Coefficient Adjustments for a DFE-Based Reference Receiver (In support of comments #313 and #314)

Roberto Rodes, Coherent

(Supporting Comments #313 and #314)

Table 180–15—Reference equalizer tap coefficients

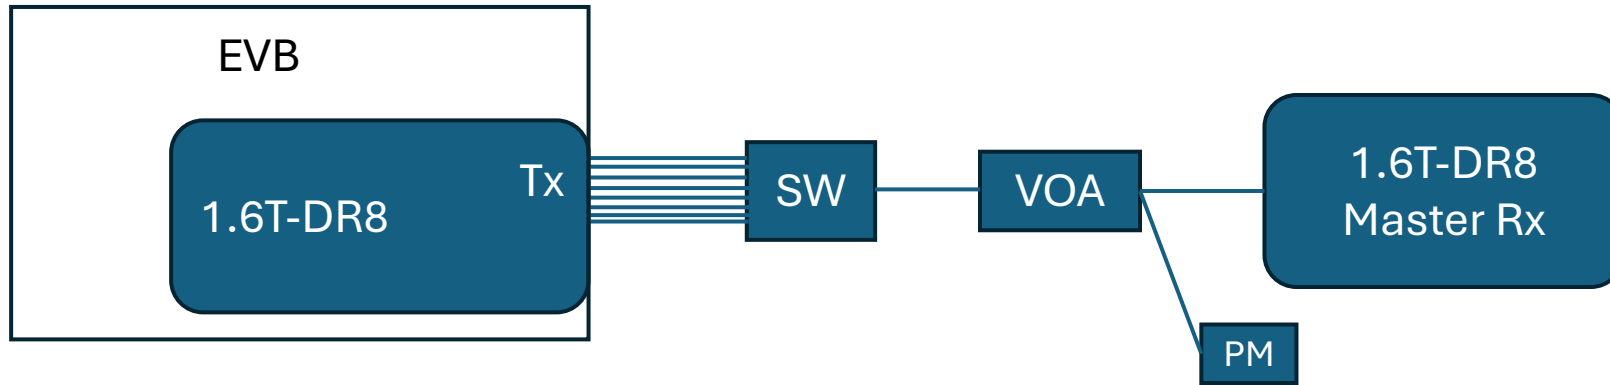
With a 1-tap DFE present, the first postcursor coefficient tends to shift toward a more positive value.

- The DFE cancels the intersymbol interference from the previous symbol.
- As a result, the FFE no longer needs to apply strong peaking at the first postcursor.

This impacts two Table 180-15 constraints:

- Minimum main tap value
- Pre-post coefficient difference

Current Spec:

Main tap min = 0.9

Pre-post difference max = 0.25

Proposed Update:

Main tap min → 0.8

Pre-post difference max → 0.55
